**ITEM FOR ENVIRONMENTAL COMMISSION AGENDA**

**NAME & NUMBER OF PROJECT:** Iglesia Pentecostal Emanuel, Inc.  
SP-2020-0324C

**LOCATION:** 6300 Moonglow Dr., Austin, TX 78724

**REQUEST:** Variance request is as follows:  
Request to vary from LDC 25-8-261 to allow development of a portion of a driveway in the Critical water Quality Zone.

2 PROPOSED SITE PLAN & BUFFER AVERAGED CWQZ SETBACK

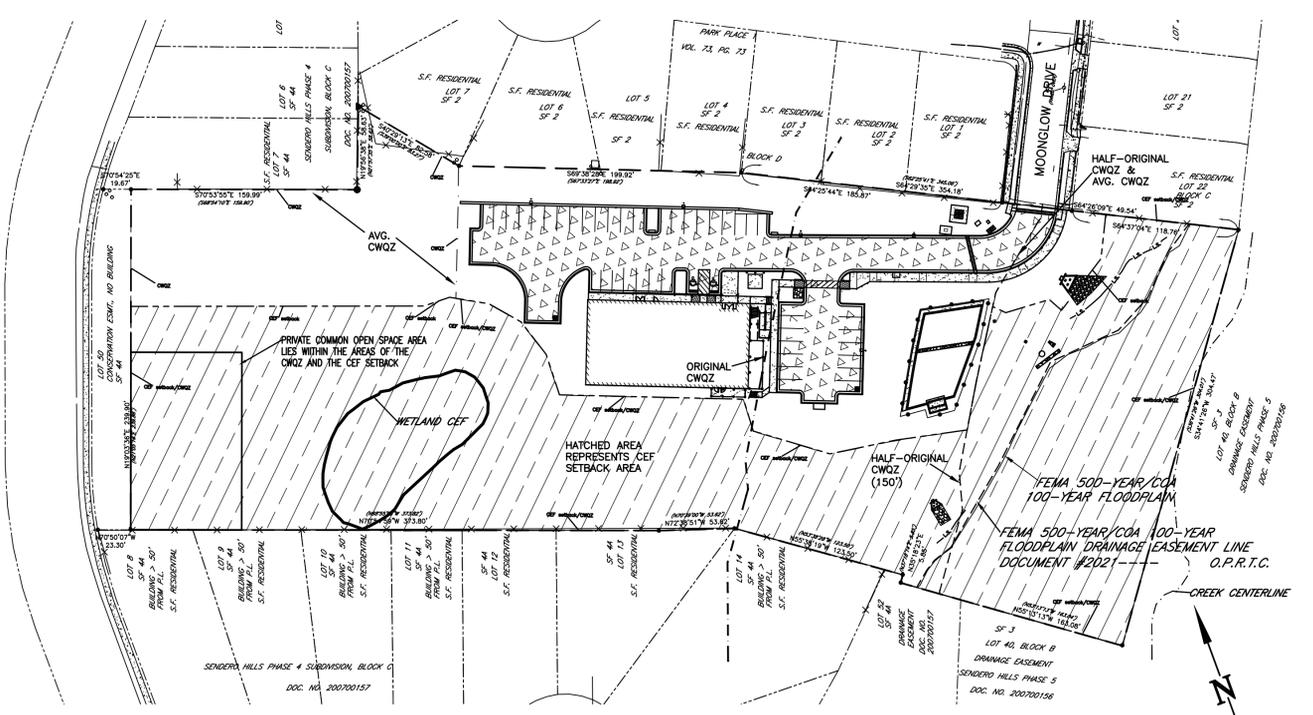
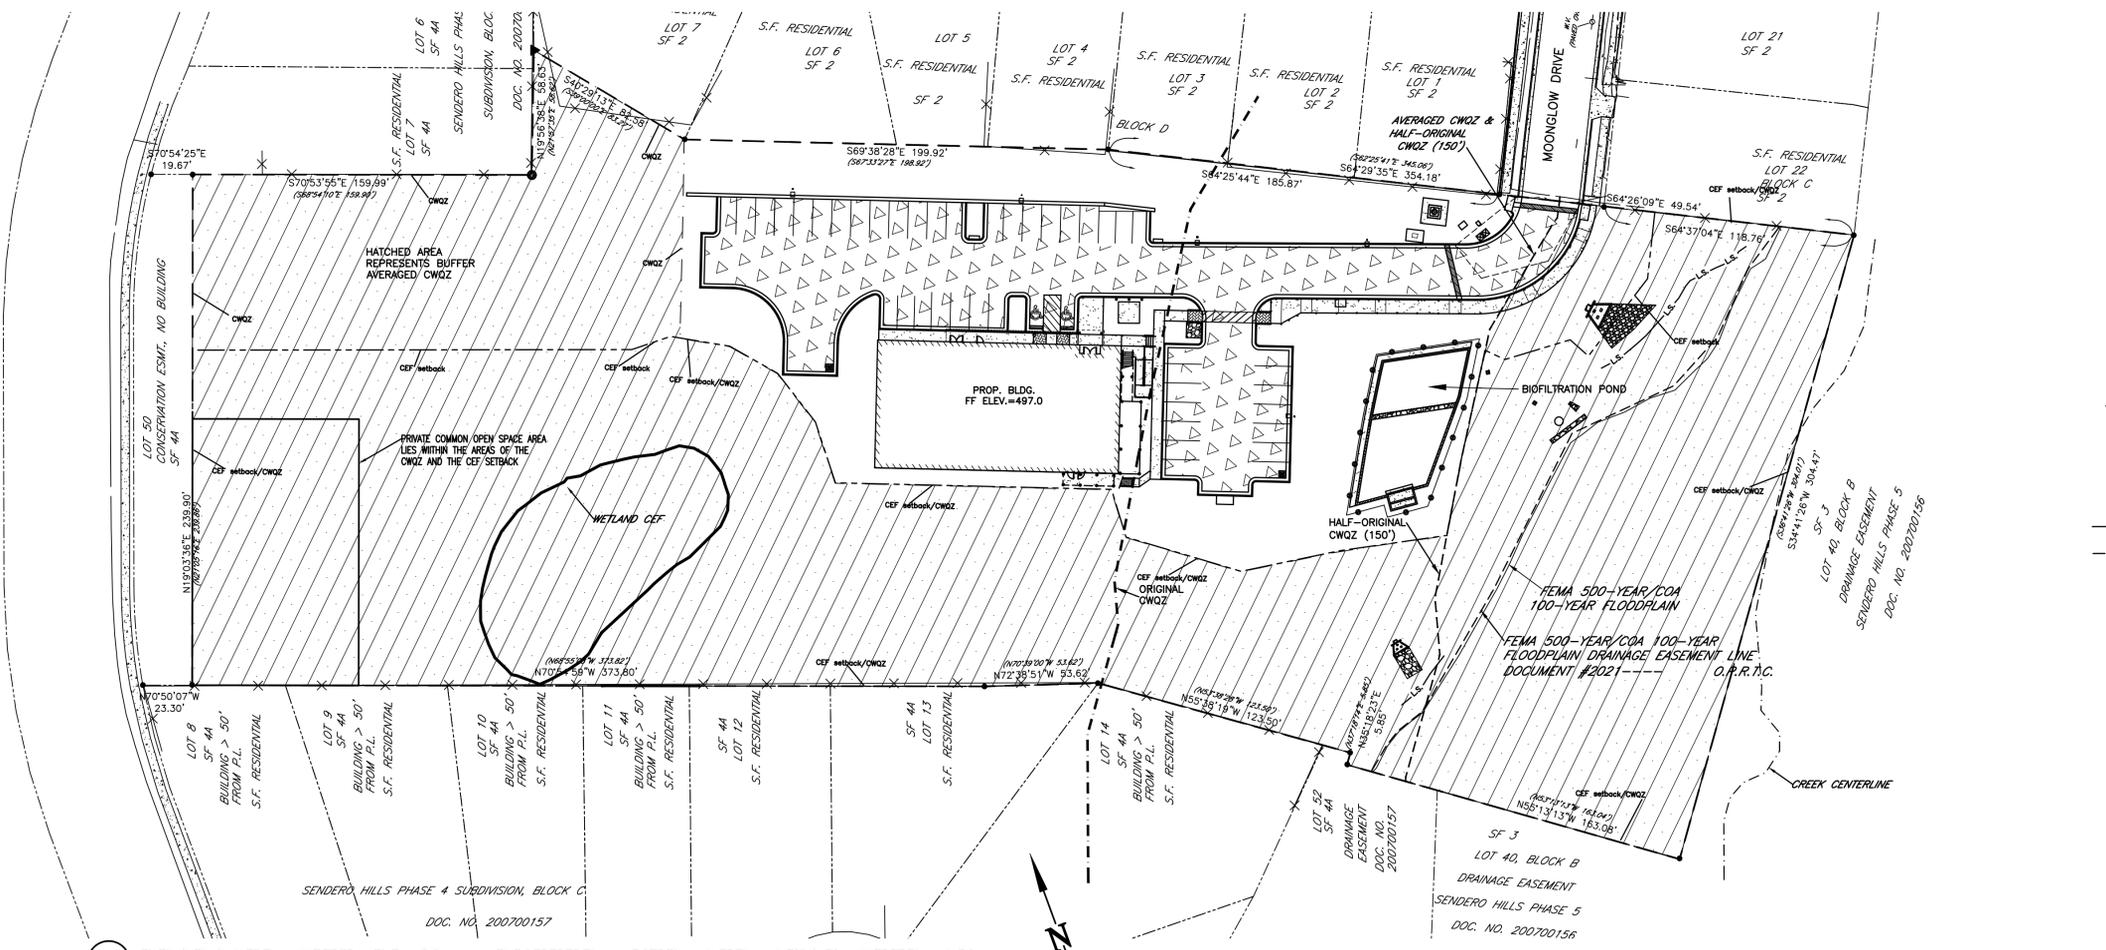
Yes The variance is not necessitated by a design decision of the applicant. The variance is necessitated by two conditions of the site that leave it without a code compliant access point.

The first site condition is that there is a previously platted open space lot, across which access is prohibited, that fronts Sandshof Dr. and lies between Sandshof Dr. and the subject site. Because of this situation, the site is forced to take its only access from Moonglow Dr.

The second site condition is that Moonglow Dr. is entirely within the Critical Water Quality Zone buffer of the adjacent, unnamed major waterway.

Since a driveway is not a permitted use in the Critical Water Quality Zone buffer per LDC 25-8-261, the project is left without a code-compliant access point.

Yes The applicant has used buffer averaging per LDC 25-8-92(B)(4) to modify and reshape the Critical Water Quality Zone buffer to remove as much of the development as possible from the buffer zone.

However, buffer averaging may not reduce the CWQZ buffer of a major waterway to less than 150 feet from the creek centerline. Due to this minimum width, it is not possible to completely remove the development from the buffer. What remains is a minimum incursion of 478 square feet of driveway.

**STAFF CONDITION:** Staff recommends the following condition: the applicant will provide bollards at appropriate locations adjacent to the drive and parking area to prevent vehicle parking off of the pavement.

Staff Determination: Staff determines that the findings of fact have been met. Staff recommends the following condition: the applicant will provide bollards at appropriate locations adjacent to the drive and parking area to prevent vehicle parking off of the pavement.
